Access Compliance Report

Public Rights-of-Way

(Curb Ramps)

Intersection ID: 10037852	Main Street: SHARON_RD	Cross Street: N/A	Location: W
ADA ID: E16475A45D04	Ramp Type: PerpDiag	Initial Pass/Fail: Fail	Overall Compliance: No
Severity Score: 12.5			
Codes/Mitigation Info/Possible Solution		Field Measurements/Component Compliance

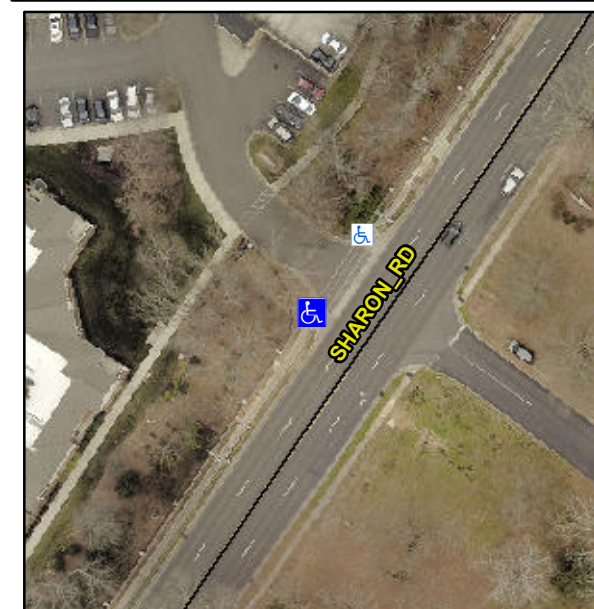
Not Found, R304.5.3

Compliance	Description	Data	Compliance	Description	Data
N/A	Ramp Length (in)	53.0	Yes	Ramp Slope (%)	6.3
Yes	Ramp Width (in)	56.0	No	Ramp XSlope (%)	5.7
N/A	Flare Type LT	N/A	N/A	Flare Type RT	N/A
N/A	Flare Slope LT (%)	N/A	N/A	Flare Slope RT (%)	N/A
N/A	Flare Traversable LT?	N/A	N/A	Flare Traversable RT?	N/A
N/A	Landing Length (in)	N/A	N/A	DWS Provided?	N/A
N/A	Landing Width (in)	N/A	N/A	DWS Contrast?	N/A
N/A	Landing Slope (%)	N/A	N/A	DWS Length (in)	N/A
N/A	Landing X Slope (%)	N/A	N/A	DWS Full Width?	N/A
N/A	Landing Curb? (Y/N)	N/A	N/A	DWS Offset (in)	N/A
N/A	Shared Landing?	N/A			
N/A	Gutter Ponding?	N/A	N/A	Gutter Slope (%)	N/A
N/A	Gutter Lip Ht (in)	N/A	N/A	Gutter X Slope (%)	N/A
N/A	Painted X Walk1?	No	N/A	Painted X Walk2?	No
	X Walk 1 Direction	To SE		X Walk 2 Direction	To NE
N/A	X Walk 1 Width (in)	N/A	N/A	X Walk 2 Width (in)	N/A
	X Walk 1 Slope (%)	7.7		X Walk 2 Slope (%)	1.5
	X Walk 1 X Slope (%)	2.3		X Walk 2 X Slope (%)	8.6

Remove & Replace Curb Ramp With Two New Directional Ramps or Equivalent.
